**SOMERS PLANNING BOARD AGENDA**  
**JUNE 10, 2020 7:30PM**

**1. COBBLING ROCK - TM: 37.19-1-1**

Re: Preliminary Subdivision Application  
Cobbling Rock Estates  
22 Dr. Tony's Road  
Sec. 37.19, Block 1, Lot 1

| DATE  | DESCRIPTION | DATE  | DESCRIPTION                    | BY |
|---|-------------|---|--------------------------------|----|
| <b>TURNING MANEUVERS</b><br>COBBLING ROCK ESTATES<br>31 DR. TOWN'S ROAD<br>TOWN OF SOMERS, WESTCHESTER COUNTY, NY 12586 |             | DATE: APRIL 28, 2020<br>SCALE: 1"=32'<br>PLOT: 000<br>DWTG: 000<br>DWG: 000 | SHEET: 1 OF 2<br>PROJECT: TM-2 |    |

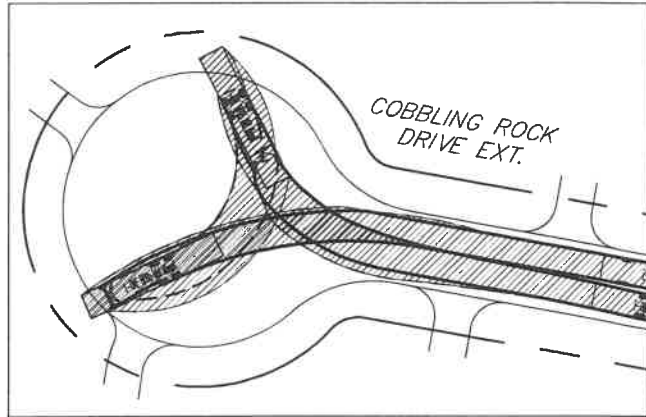
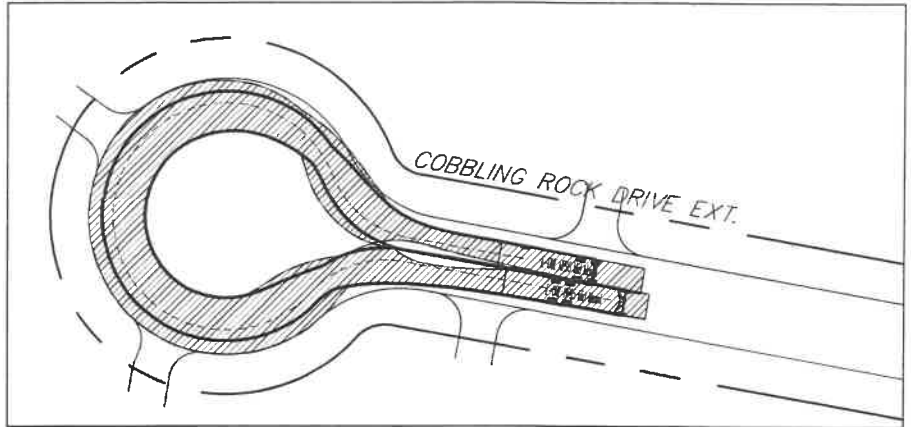
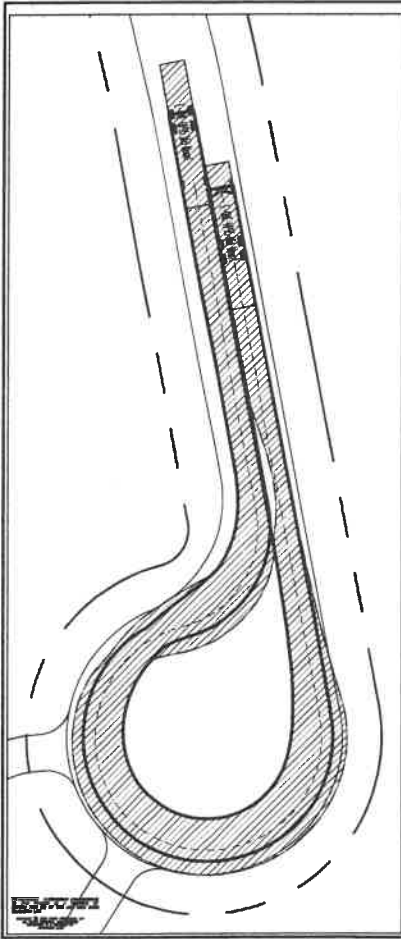
We are aware that NYS Fire Code specifies a minimum diameter of 96' for cul-de-sacs, however as noted above, on past projects the dimensional requirements listed in the Town Code are what was adhered to for road design standards. It should also be noted that the Town Bureau of Fire Prevention accepted the 90' diameter cul-de-sacs at their April 15, 2020 meeting.

**WHEREAS**, the Bureau of Fire Prevention in comments in its many memorandums to the Planning Board as noted above, indicated its concern regarding whether a tower ladder fire truck could be accommodated in the proposed 90' cul-de-sacs and indicated that a 96 inch diameter cul de sac should be provided in compliance with the 2015 International Fire Code Appendix D standard; and

In response to your request please find enclosed copies of Turning Maneuver Plans created by our office dated April 29, 2020, for the proposed cul-de-sacs for the above noted project.

Please note the Town Road extensions and cul-de-sacs proposed for the Cobbling Rock Estates subdivision have been designed in accordance with all specified dimensional requirements listed in the Town Code. The cul-de-sacs shown on the project plans have a diameter of 90' per §A174-31 of the Town Code, which is consistent with past precedent on recently approved projects in the Town of Somers.

**WHEREAS**, by letter dated May 28, 2020, Bibbo Associates submitted a Truck Maneuver plan showing that the 90' cul de sac can accommodate a 48' ladder truck and complies with the 90' diameter requirement of Section A174-31 of the Town Code; and
